Correspondence Between Staff and Applicant

GENTRY ON THE GREEN – 1st REVIEW LETTER – APPLICANT RESPONSES

11-ZN-2019

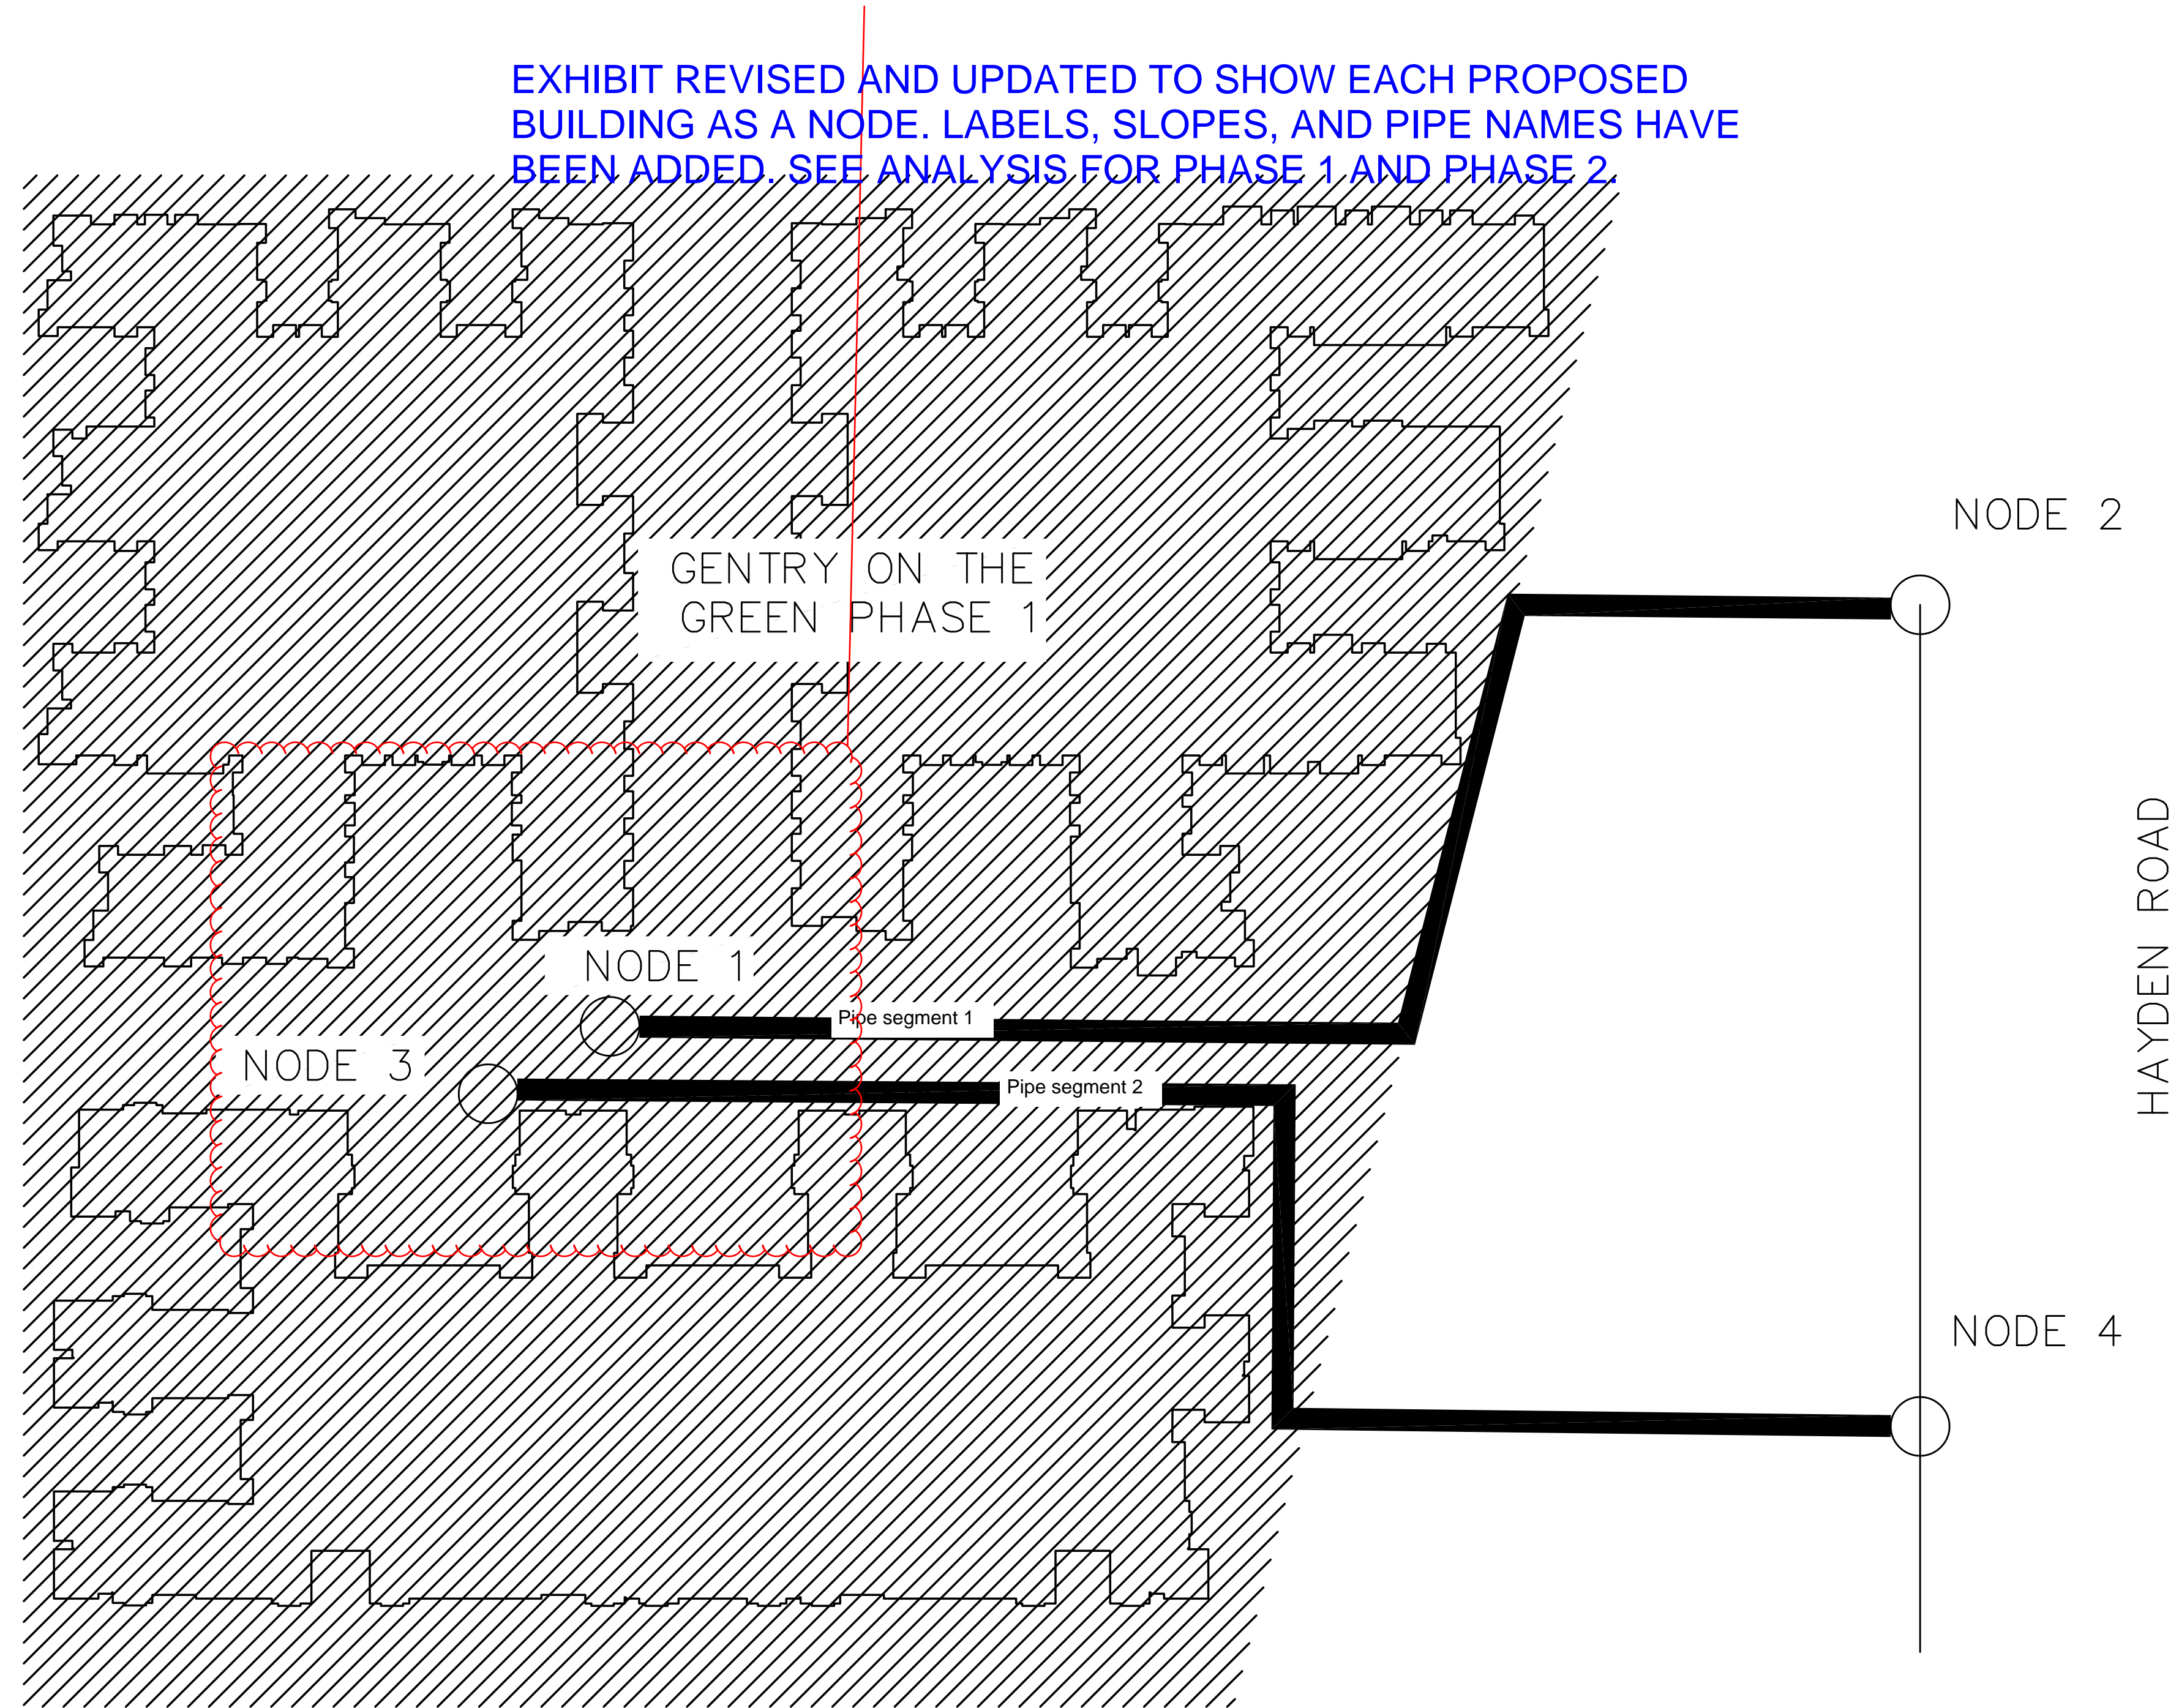
Where is analysis for this section?? Needs to extend to Miller.

EXHIBIT REVISED AND UPDATED TO SHOW PHASE 2, WHICH INCLUDES THE UPSIZING OF THE PIPE TO THE INTERSECTION OF MILLER ROAD AND INDIAN SCHOOL ROAD.

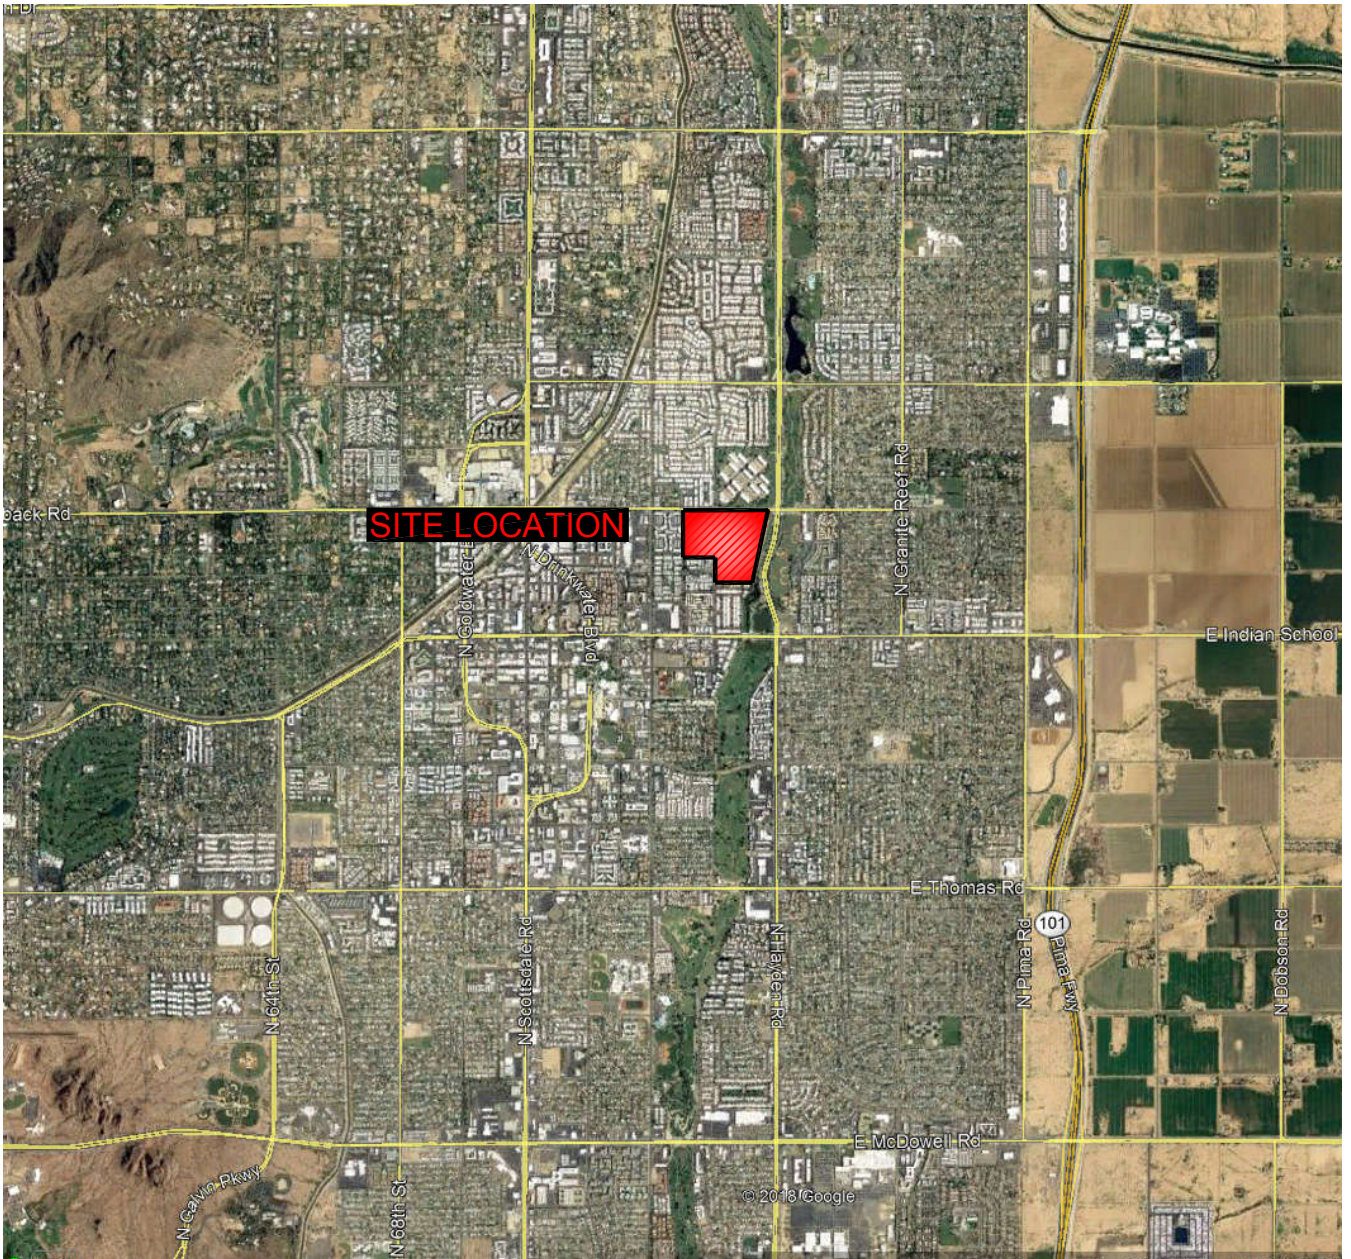
spell

need best approximation of Phase 2 and associated analysis as part of this case.

MODELING RESULTS ARE NOW BEING REFERENCED AND THE MODELING PROCESSED HAS BEEN FURTHER EXPLAINED IN THE REPORT.

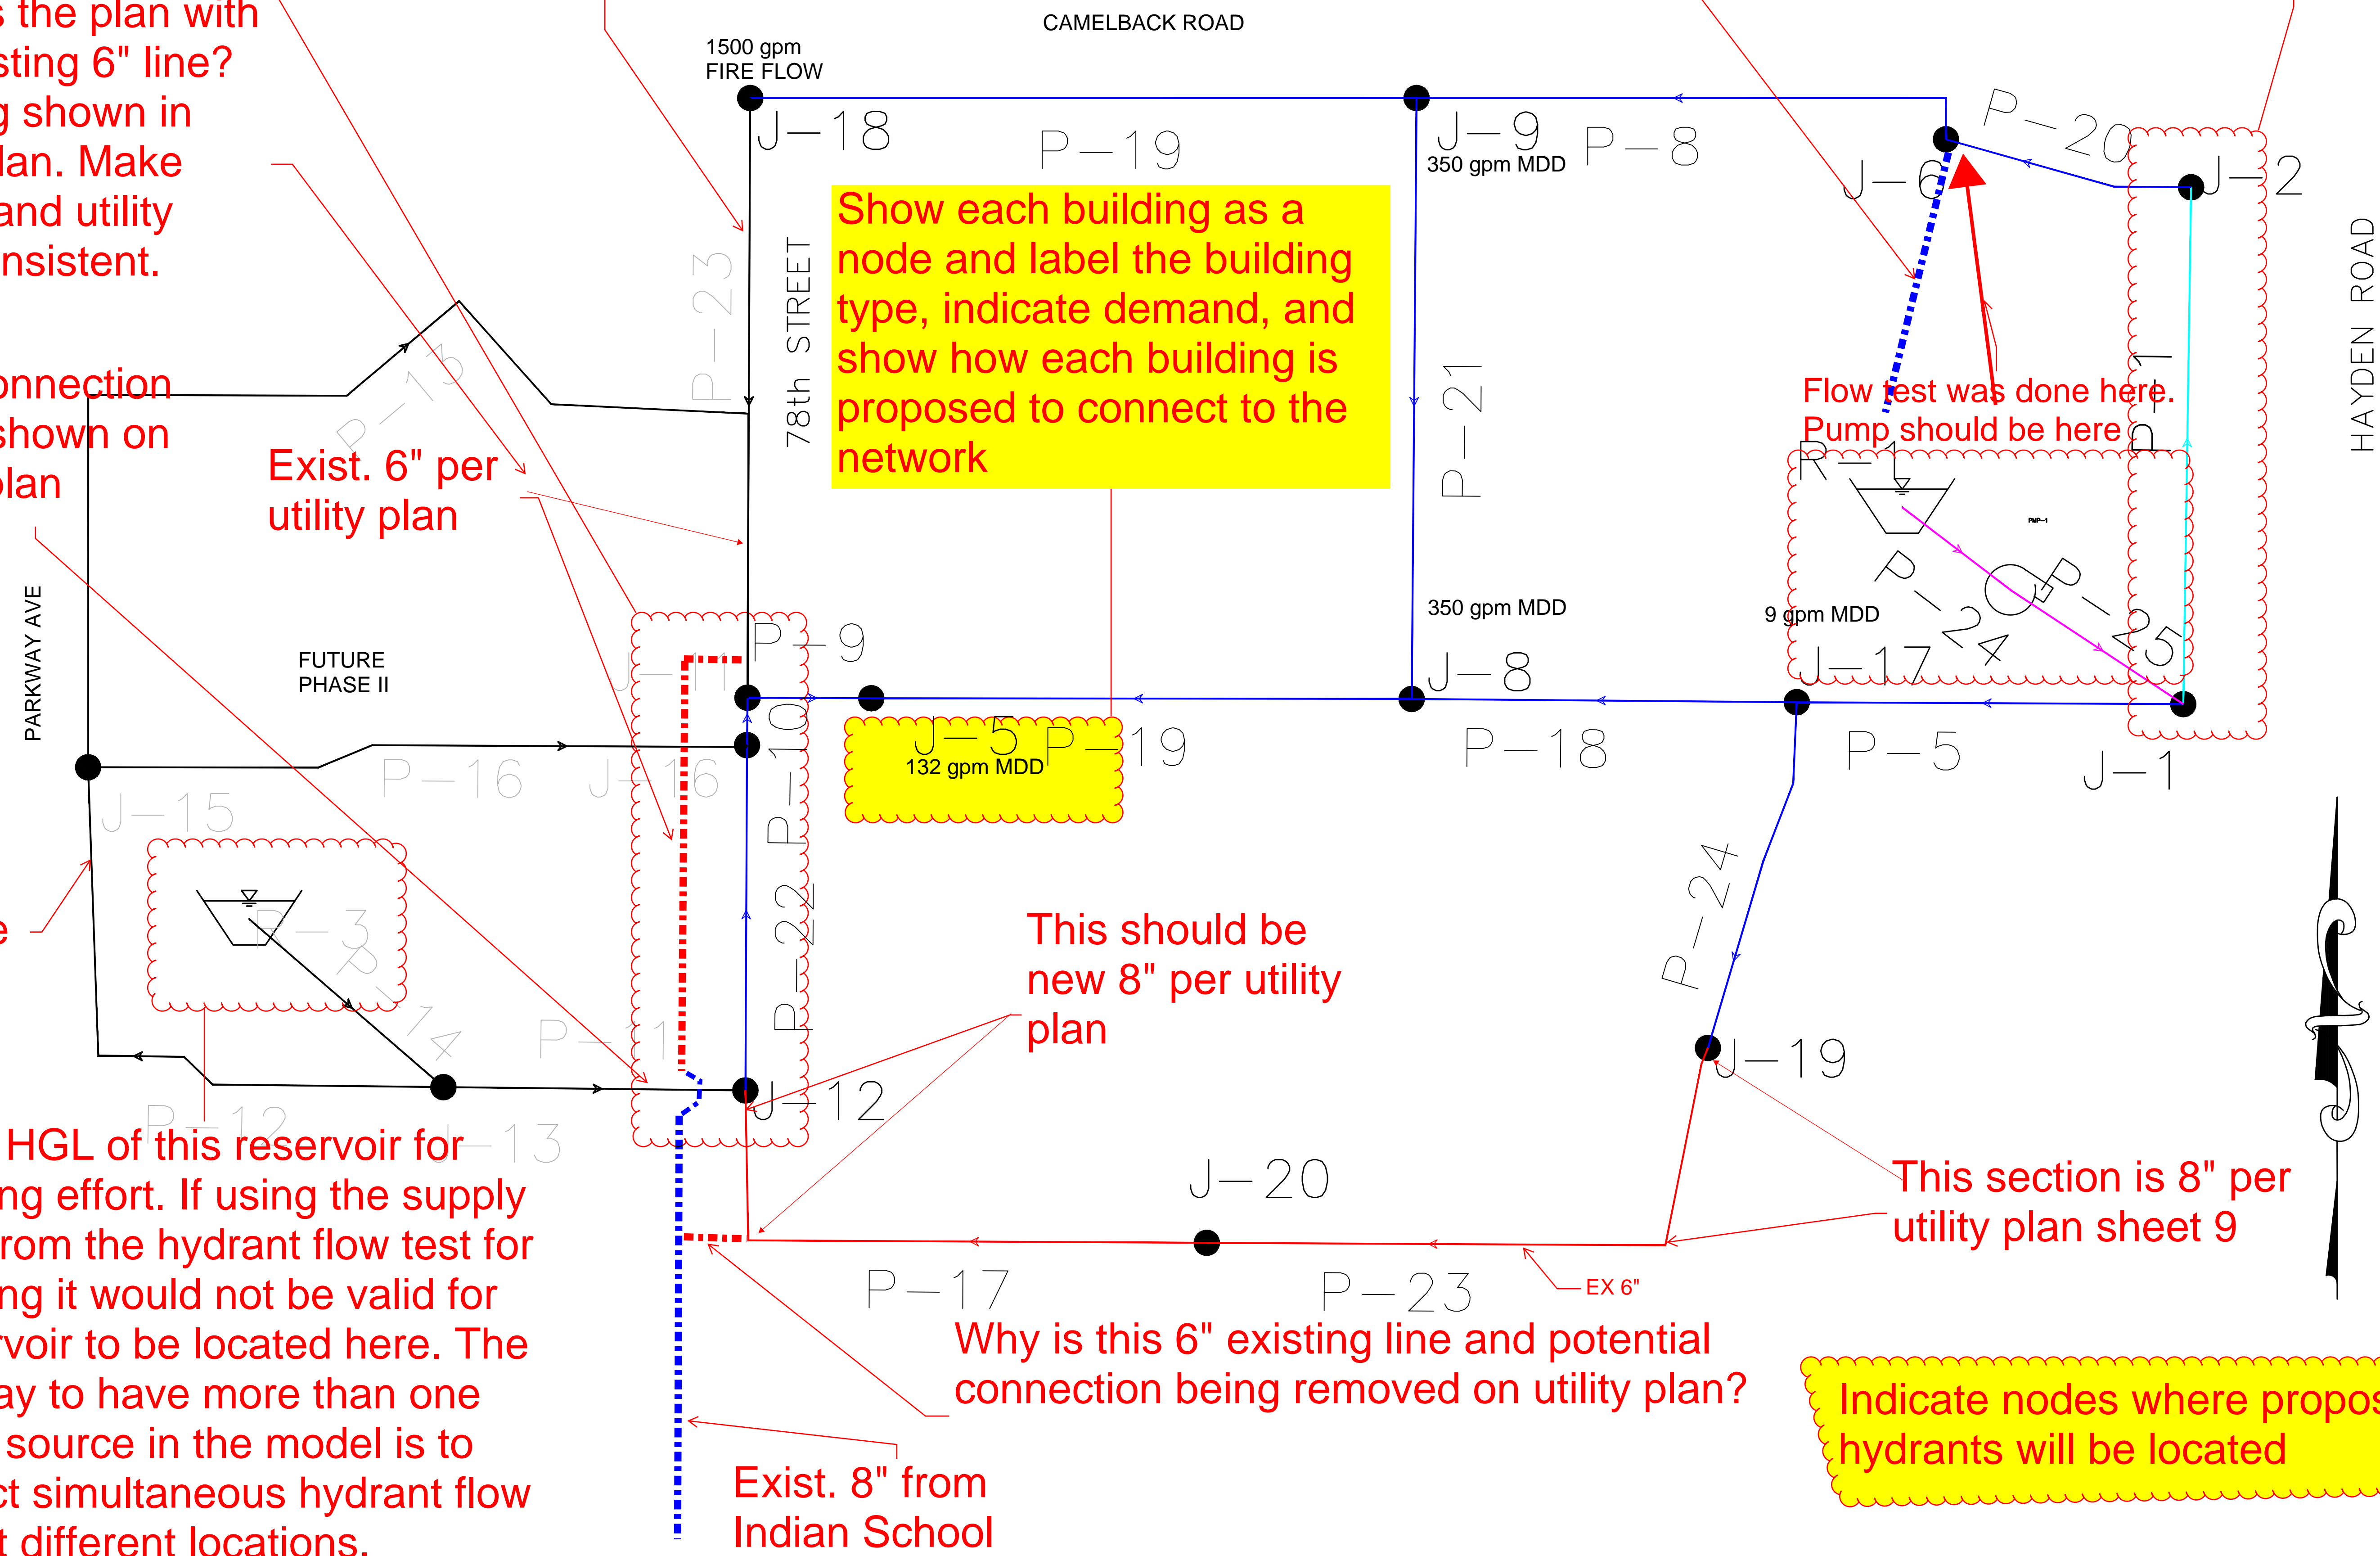
This should be new 8" per utility plan

Define HGL of this reservoir for modeling effort. If using the supply curve from the hydrant flow test for modeling it would not be valid for a reservoir to be located here. The only way to have more than one supply source in the model is to conduct simultaneous hydrant flow tests at different locations.

This section is 8" per utility plan sheet 9
